# UNITED STATES PATENT AND TRADEMARK OFFICE

APPLICATION NO.	FILING DATE	FIRST NAMED INVENTOR	ATTORNEY DOCKET NO.	CONFIRMATION NO.
10/811,374	03/26/2004	Robert H. Bush	EH-11234 (04-224)	2083

**Office Action Summary**

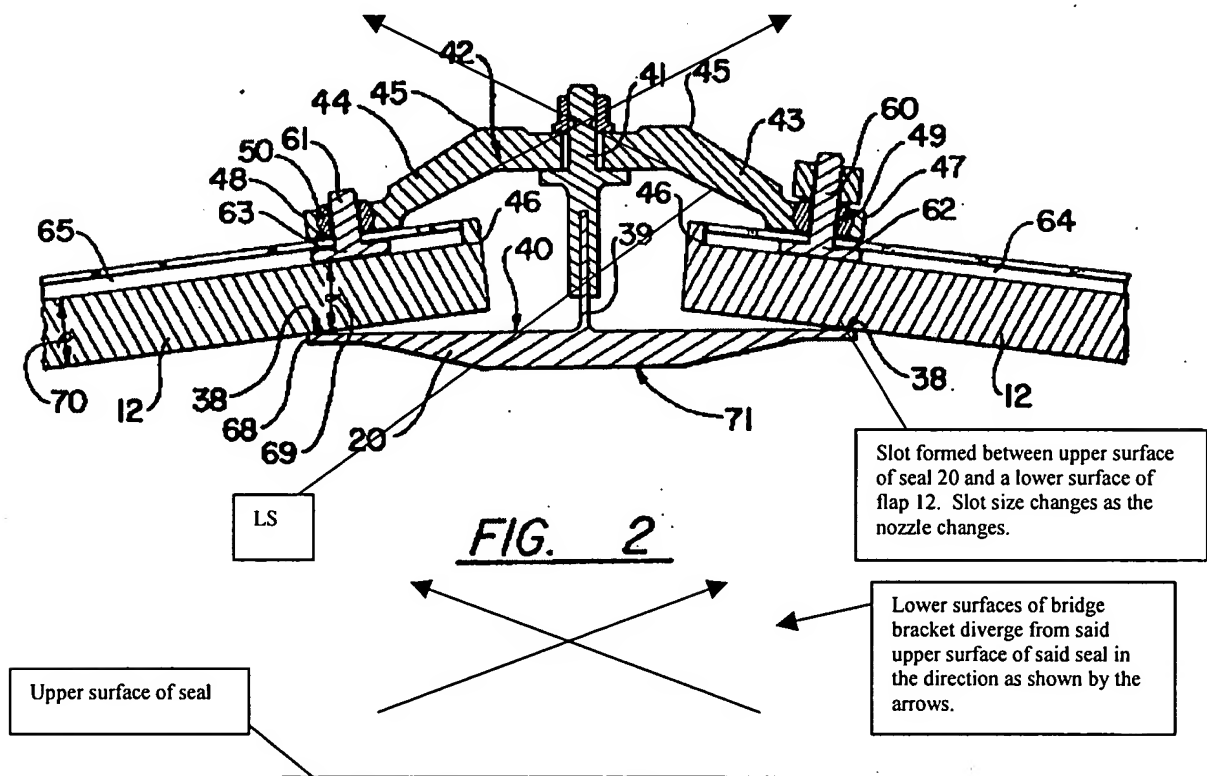
42 positioned intermediate adjacent ones of said divergent flaps 12; each said bridge member 42 including a bridge bracket (43, 44) and a sealing element 20 joined to said bridge bracket (43, 44); said sealing element 20 having an upper surface 40; and said bridge bracket having a lower surface LS which diverges from said upper surface of said sealing element 20. See particularly **Figure 2** of Barcza above.

With respect to claim 2, **Barcza** teaches that the divergent flaps 12 move relative to said lower surface LS so that in an overexpanded condition of said nozzle having a first nozzle throat area, a first slot is created between said upper surface of said seal member and lower surfaces of said flaps. See particularly **Figure 2**, column 4 lines 44-55 of Barcza.

With respect to claim 3, **Barcza** teaches that the divergent flaps 12 move relative to said lower surfaces so that in an overexpanded condition of said nozzle having a second nozzle throat area smaller than said first nozzle throat area, a second slot smaller than said first slot is created between said upper surface of said seal member and said lower surfaces of said flaps. See particularly **Figure 2**, column 4 lines 44-55 of Barcza.

With respect to claim 4, **Barcza** teaches that the nozzle further comprises means (39, 41) for joining said sealing element 20 to said bridge bracket (43, 44). See particularly **Figure 2** of Barcza above.

With respect to claim 5, **Barcza** teaches that the bridge bracket (43, 44) is shaped to allow variable slot size depending on nozzle throat jet area. See particularly **Figure 2**, column 4 lines 21-24 of Barcza.

With respect to claim 6, **Barcza** teaches that said divergent flaps 12 define a nozzle surface area and said flaps 12 being spaced apart by gaps\* which comprise from 3.0% to 30% of said nozzle throat surface area. See particularly **Figure 2** of Barcza above.

\*The gap between adjacent flaps appears to be within the claimed range of 3.0% to 30%.

With respect to claim 7, **Barcza** teaches that said divergent flaps 12 are spaced apart by gaps\* which comprise from 8.0% to 12.0% of said nozzle throat surface area. See particularly **Figure 2** of Barcza above.

With respect to claim 8, **Barcza** teaches an ejector nozzle bridge member 42 comprising: a bridge bracket (43, 44); a sealing element 20 joined to said bridge bracket; said sealing element having an upper surface 40; and said bridge bracket having a lower surface LS which diverges from said upper surface of said sealing element. See particularly **Figure 2** of Barcza above.

With respect to claim 9, **Barcza** teaches that the sealing element 20 has a central portion and end portions an angle to said central portion. See particularly **Figure 2** of Barcza above.

With respect to claim 10, **Barcza** teaches that the ejector nozzle bridge member further comprises: a backbone support (39, 41) attached to said sealing element 20; said bridge bracket 42 fitting over said backbone support; and means for securing said bridge bracket on said backbone support. See particularly **Figure 2** of Barcza above.

With respect to claim 11, **Barcza** teaches that the bridge bracket (43, 44) is shaped to allow variable slot size depending on nozzle throat jet area. See particularly **Figure 2**, column 4 lines 21-24 of Barcza.

With respect to claim 12-22, **Barcza** teaches a nozzle for an engine comprising: a plurality of spaced apart divergent flaps 12; means 34 for moving said divergent flaps 12; a bridge member 42 positioned intermediate adjacent ones of said divergent flaps 12; each said bridge member 42 including a bridge bracket (43, 44) and a sealing element 20 joined to said bridge bracket (43, 44); said sealing element 20 having an upper surface 40; and said bridge bracket having a lower surface LS which diverges from said upper surface of said sealing element 20. Since **Barcza** has the same structure as claimed, it is inherent that **Barcza's** ejector nozzle would be able to perform the recited method steps of claims 12-22. See particularly **Figure 2**, column 4 lines 21-24; and column 4 lines 44-55 of **Barcza**.

FIG. 3

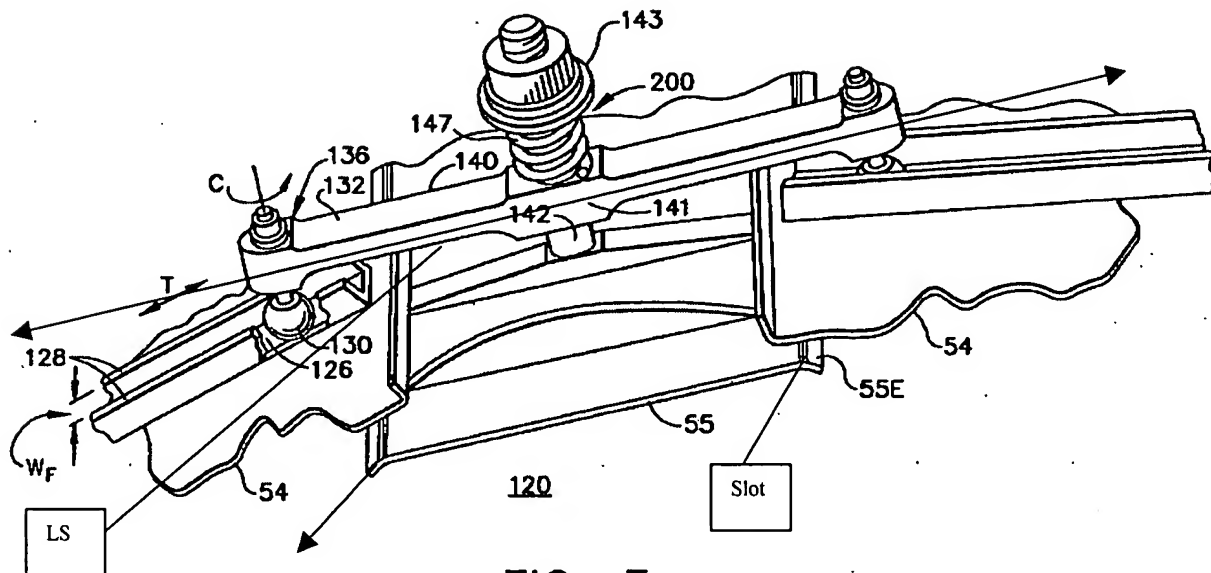
With respect to claim 1, **Ausdenmoore** teaches a nozzle for an engine comprising: a plurality of spaced apart divergent flaps 54; means 90 for moving said divergent flaps 54; a bridge member 141 positioned intermediate adjacent ones of said divergent flaps 54; each said bridge member 141 including a bridge bracket 132 and a sealing element 55 joined to said bridge bracket 132; said sealing element 55 having an upper surface 55E which diverges from a lower surface LS of said bridge bracket. See particularly **Figure 3** of **Ausdenmoore** above.

\*a sealing element having an upper surface which diverges from a lower surface of a bridge bracket is interpreted to mean the same or be equivalent to a bridge bracket having a lower surface which diverges from an upper surface of a sealing element.

With respect to claim 2, **Ausdenmoore** teaches that the divergent flaps 54 move relative to said lower surface LS so that in an overexpanded condition of said nozzle having a first nozzle

throat area, a first slot is created between said upper surface of said seal member and lower surfaces of said flaps. See particularly **Figure 3** of Ausdenmoore above..

With respect to claim 3, **Ausdenmoore** teaches that the divergent flaps 54 move relative to said lower surfaces so that in an overexpanded condition of said nozzle having a second nozzle throat area smaller than said first nozzle throat area, a second slot smaller than said first slot is created between said upper surface of said seal member and said lower surfaces of said flaps. See particularly **Figure 3** of Ausdenmoore above..

With respect to claim 4, **Ausdenmoore** teaches that the nozzle further comprises means 142 for joining said sealing element 55 to said bridge bracket 132. See particularly **Figure 3** of Ausdenmoore above.

With respect to claim 5, **Ausdenmoore** teaches that the bridge bracket 132 is shaped to allow variable slot size depending on nozzle throat jet area. See particularly **Figure 3** of Ausdenmoore above.

With respect to claim 6, **Ausdenmoore** teaches that said divergent flaps 54 define a nozzle surface area and said flaps being spaced apart by gaps\* which comprise from 3.0% to 30% of said nozzle throat surface area. See particularly **Figure 3** of Ausdenmoore above.

With respect to claim 7, **Ausdenmoore** teaches that said divergent flaps 54 are spaced apart by gaps\* which comprise from 8.0% to 12.0% of said nozzle throat surface area. See particularly **Figure 3** of Ausdenmoore above.

With respect to claim 8, **Ausdenmoore** teaches an ejector nozzle bridge member 141 comprising: a bridge bracket 132 and a sealing element 55 joined to said bridge bracket 132; said sealing element 55 having an upper surface 55E which diverges from a lower surface LS of said bridge bracket. See particularly **Figure 3** of Ausdenmoore above.

With respect to claim 9, **Ausdenmoore** teaches that the sealing element 55 has a central portion and end portions an angle to said central portion. See particularly **Figure 3** of Ausdenmoore above.

With respect to claim 10, **Ausdenmoore** teaches that the ejector nozzle bridge member further comprises: a backbone support 142 attached to said sealing element 55; said bridge bracket 132 fitting over said backbone support; and means for securing said bridge bracket on said backbone support. See particularly **Figure 3** of Ausdenmoore above.

With respect to claim 11, **Ausdenmoore** teaches that the bridge bracket 132 is shaped to allow variable slot size depending on nozzle throat jet area. See particularly **Figure 3** of Ausdenmoore above.

With respect to claim 12-22, **Ausdenmoore** teaches a nozzle for an engine comprising: a plurality of spaced apart divergent flaps 54; means 90 for moving said divergent flaps 54; a bridge member 141 positioned intermediate adjacent ones of said divergent flaps 54; each said bridge member 141 including a bridge bracket 132 and a sealing element 55 joined to said bridge bracket 132; said sealing element 55 having an upper surface 55E which diverges from a lower

surface LS of said bridge bracket. Since **Ausdenmoore** has the same structure as claimed, it is inherent that **Ausdenmoore**'s ejector nozzle would be able to perform the recited method steps of claims 12-22. See particularly **Figure 3** of Ausdenmoore above.
